Title of Change:	Revision of Case Outline 507BE
Effective date:	05 Jul 2024
Contact information:	Contact your local onsemi Sales Office or Sarmila.Kamalanathan@onsemi.com
Type of notification:	This Product Bulletin is for notification purposes only. onsemi will proceed with implementation of this change upon publication of this Product Bulletin.
Change Category:	Assembly Change
Change Sub-Category(s):	Datasheet/Product Doc change

MECHANICAL CASE OUTLINE
PACKAGE DIMENSIONS

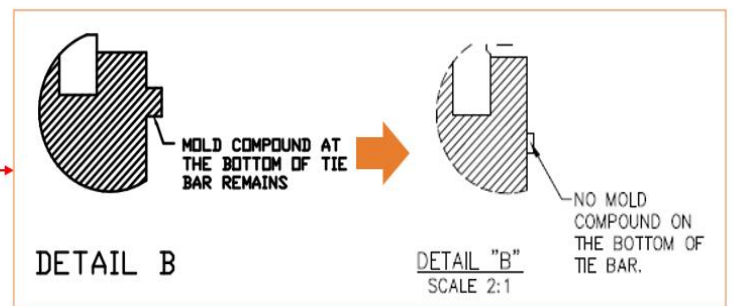
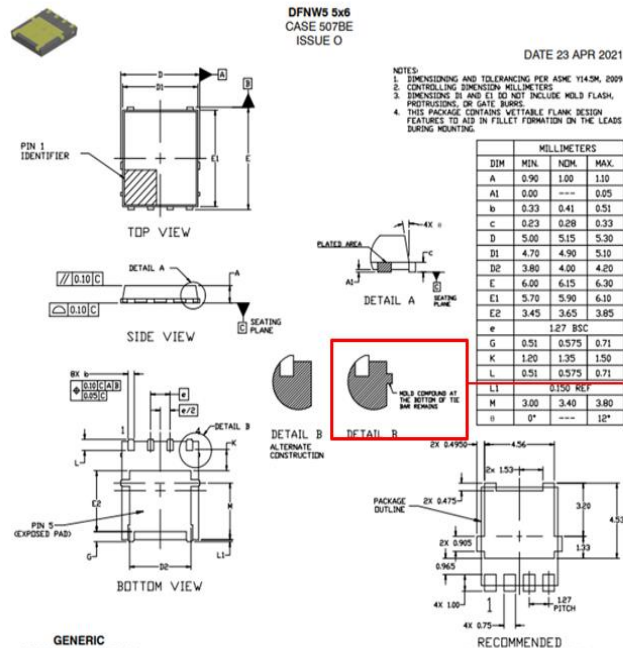
This Product Bulletin is to advise customers of a change to detail B in case outline from “Mold compound at the bottom of tie bar remains” to “No mold compound at the bottom of the tie bar” for case 507BE. No change to solder footprint is required. There is no material, dimension or manufacturing change.
